3 VOLT FlashFile™ MEMORY

28F004S3, 28F008S3, 28F016S3

SPECIFICATION UPDATE

Order Number: 297799-009

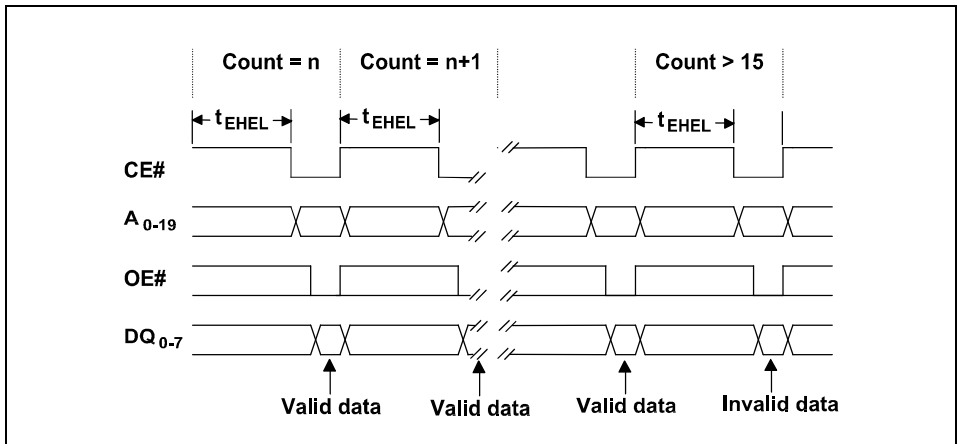
PROBLEM: For the 8- and 16-Mbit devices that are effected by this erratum, the block unlocking security feature is currently nonfunctional. Attempts to unlock blocks, using the clear block lock-bits command sequence, may cause subsequent program and/or block erase failures. The failure is seen as a device protection error in the status register.

IMPLICATION: Block unlocking feature is disabled. This erratum effects the following command, Clear Block Lock-Bits. Locking blocks using the Set Block Lock-bits command (while RP# is equal to 12 volts) is still supported.

WORKAROUND: To prevent accidental software block lock-bit clearing, Intel permanently sets the master lock-bit during the test flow. This disables the ability to lock and unlock blocks via software only with RP# = V_{IH} . Block locking and unlocking requires 12 V on the component's RP# input when the master lock-bit is set. Don't execute the clear block lock-bits command sequence when 12 V is applied to RP#. Instead, simply override the block locking mechanism by applying 12 V to RP# to enable program/erase operations that target locked blocks.

If data security is of utmost importance, lower V_{PP} voltage equal to or less than V_{PPLK} during normal operations. With V_{PP} equal to or less V_{PPLK} , the device is protected against all data manipulation operations.

Successive Read Operations That Have Long CE#-High Pulse Widths

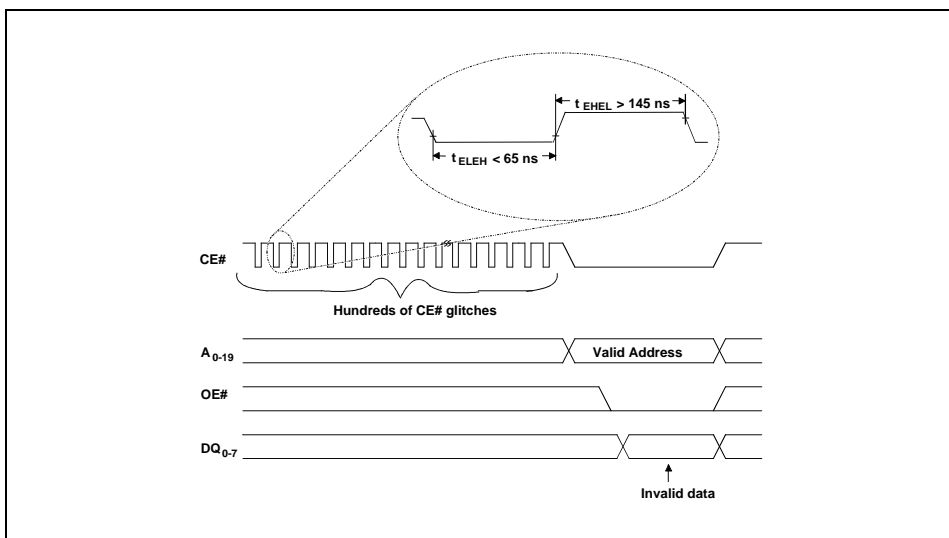
PROBLEM: The component may return invalid data if more than fifteen successive read operations are performed where CE# is deasserted between each read and the corresponding CE#-high pulse width resides within the specifications outlined in the table below.

IMPLICATION: If it is determined that CE#-high time violations occur, carefully examine subsequent reads. If the ratio of good to bad (CE#-high times within the specifications outlined in the table above) reads is high, your system may not have a problem. For every bad read the system performs, five good reads for A-1 and A-3 stepping and two good reads for A-6 stepping are needed to cancel the effect of the bad read. So, carefully analyze the flash memory CE# input to understand the CE#-high characteristic.

1. Read more than four good reads for A-1 and A-3 stepping and only one read for A-6 stepping during each assertion of CE#, as illustrated in the figure above.
2. Issue a Byte Write command and program FFh to any location before executing a read operation. Programming FFh will not alter stored data, but it will give the component sufficient time to prepare for the read operation.

A Long Series of CE# Glitches May Induce an Invalid Read

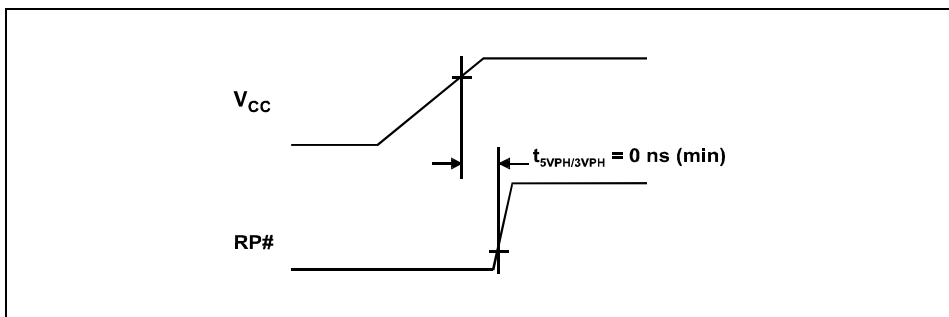
PROBLEM: A noisy CE# control signal may cause an invalid read. This erroneous read only occurs after the device has received over one hundred consecutive short CE# glitches ($t_{EHL} < 65$ ns) with CE#-high time (t_{EHL}) greater than 145 ns (see the figure below, *A Long Series of CE# Glitches May Induce an Invalid Read*).

After valid data is read, the device must receive another series of CE# glitches (typically over one hundred) to induce an invalid read.

Add system logic to prevent CE# glitches such as latched CE# control logic or pullup/pulldown resistors to the address bus.

If the device receives over one hundred consecutive CE# glitches, issue a Byte Write command and program FFh to any location before executing a read operation. Programming FFh will not alter stored data, but it will give the component sufficient time to prepare for the read operation.
